CONVAIR
A Division of General Dynamics Corporation
San Diego, California

COMMERCIAL CHANGE PROPOSAL

SPNO NO: ZD-22-003 DATE: _____
CUSTOMER: Delta Air Lines Inc. MCL 10,158 Dtd _____
CHANGE NO: 100 MODEL: (880) 22-2

TITLE: **Tinted Interior Cabin Windows, Installation of**

FIGURE 3.19-GA

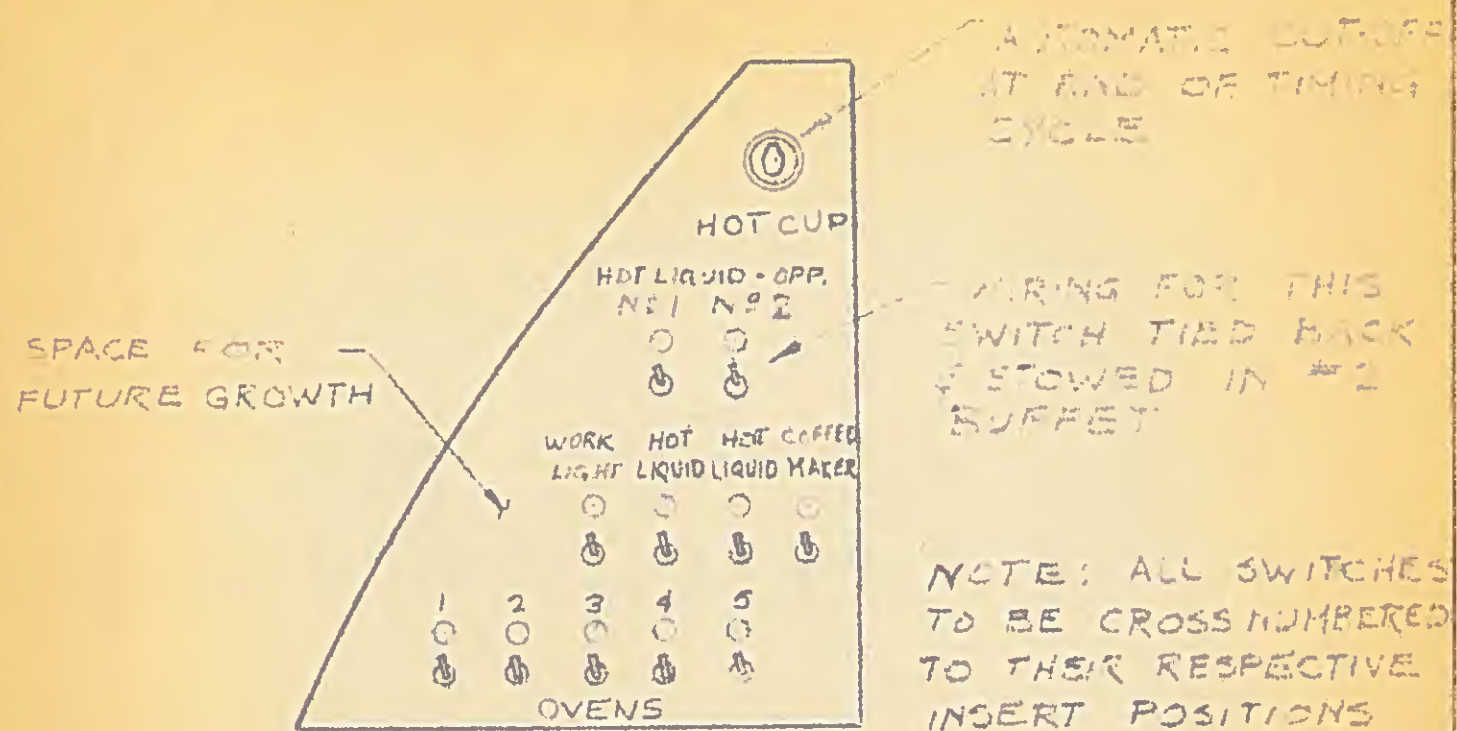
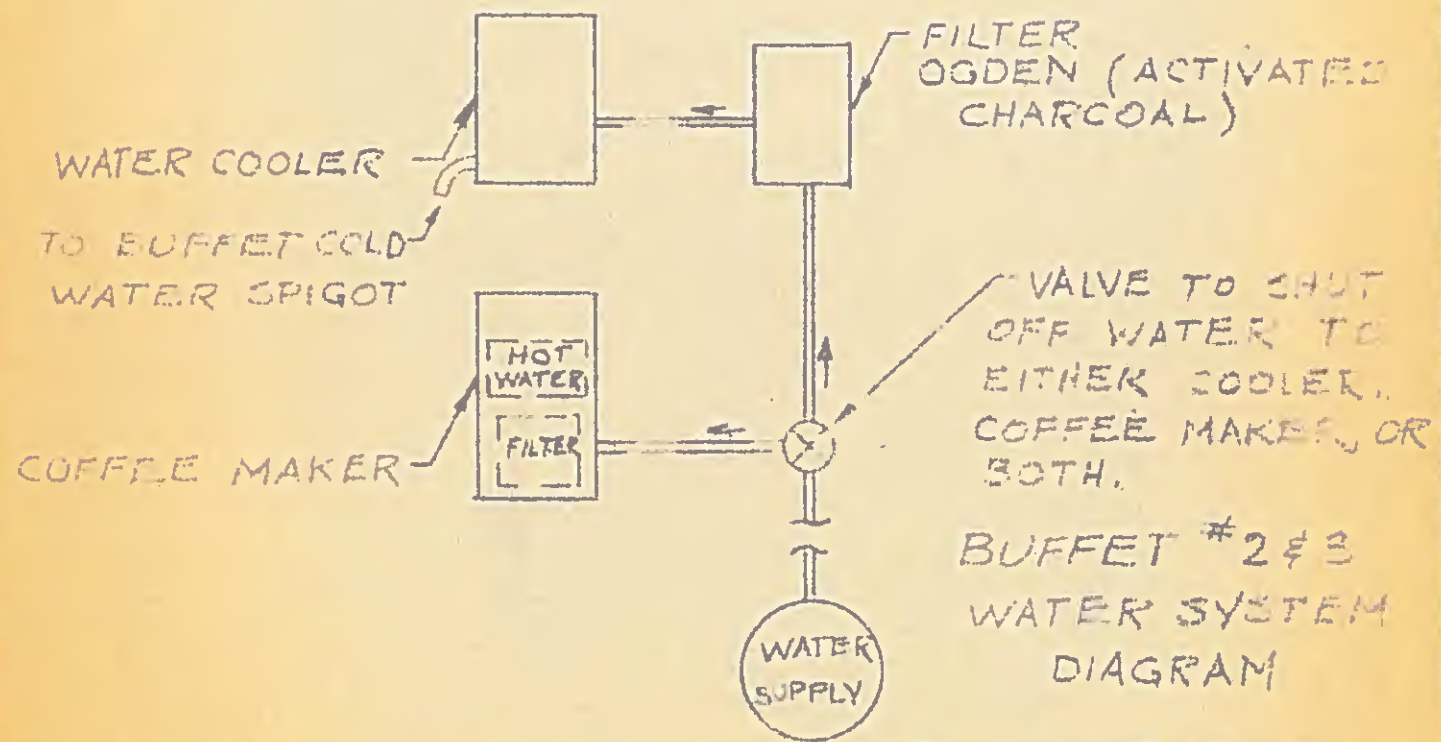
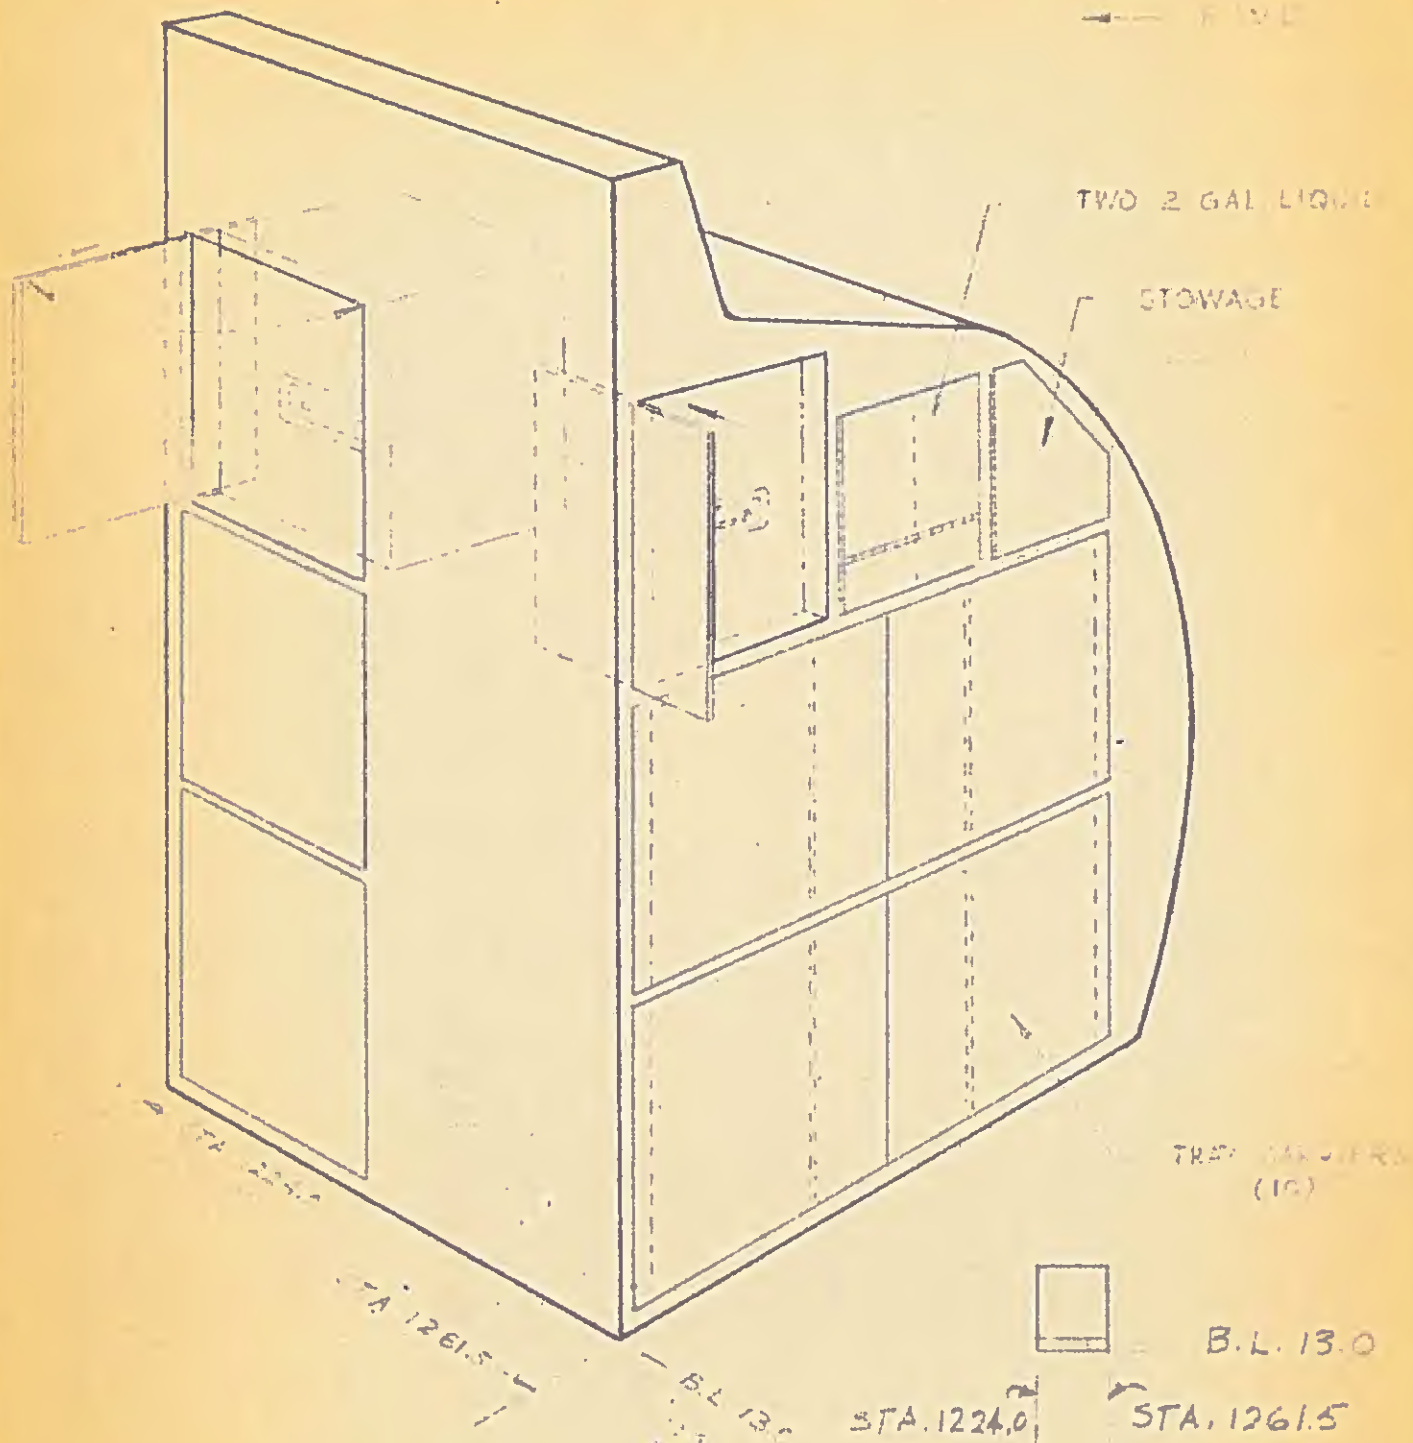
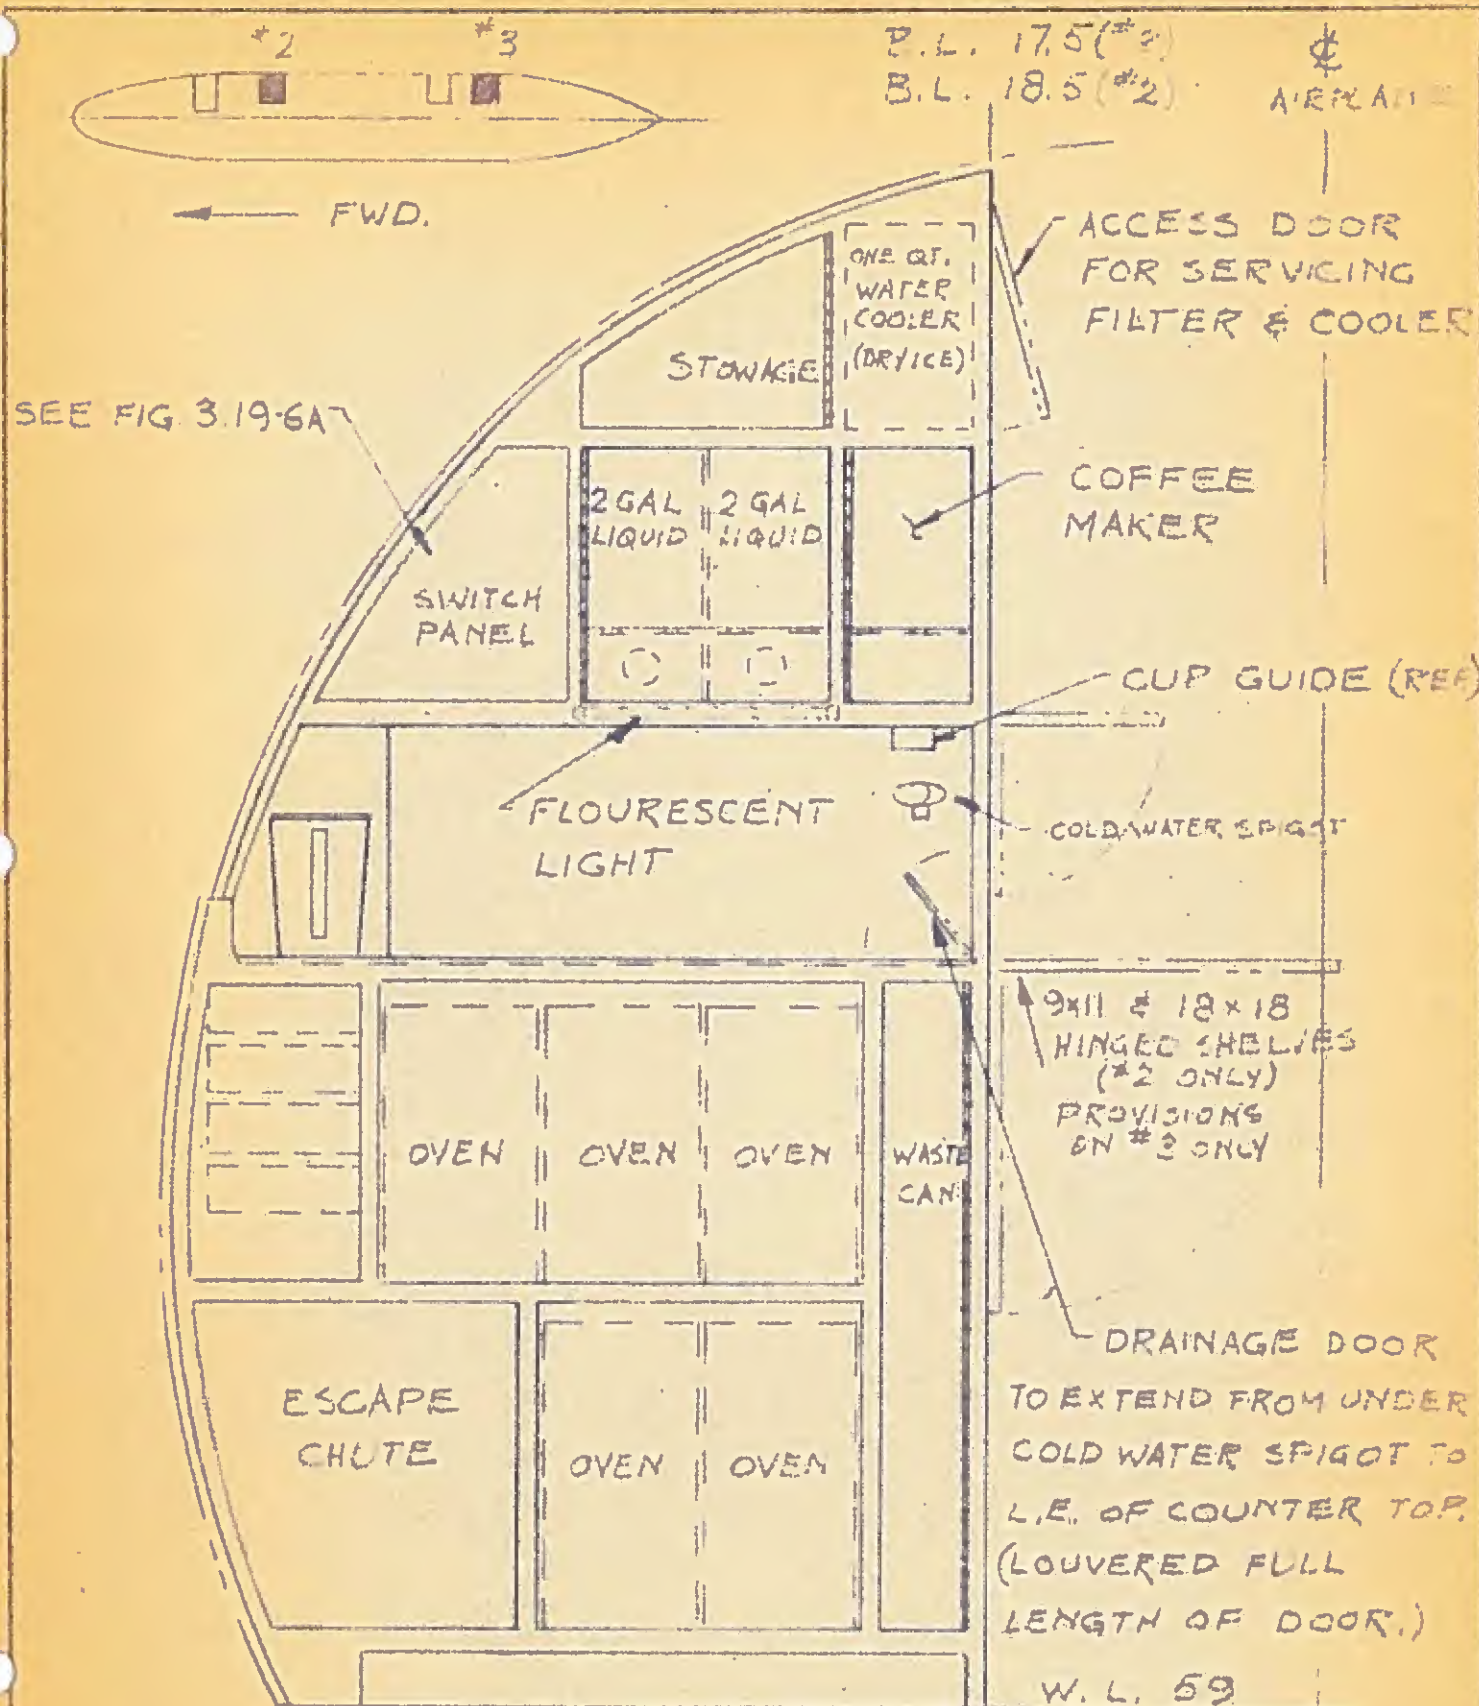
Enclosures: (A) Four (4) copies Figure 3.19-5 Revision C
(B) Four (4) copies Figure 3.19-6 Revision C
(C) Four (4) copies Figure 3.19-6A Revision A
(D) Four (4) copies Figure 3.19-7 Revision A, Alt. B

Figure 1-2 - Inboard Profile and Plan View and
Figure 1-3 - Alternate Seating Arrangement, will be revised in
accordance with this Change No. 35B as follows:

II. Right hand movable coat rack will be provided as loose equipment.

III. Convair will use a total of 614 pounds for Customer food service in Convair useful load calculations.
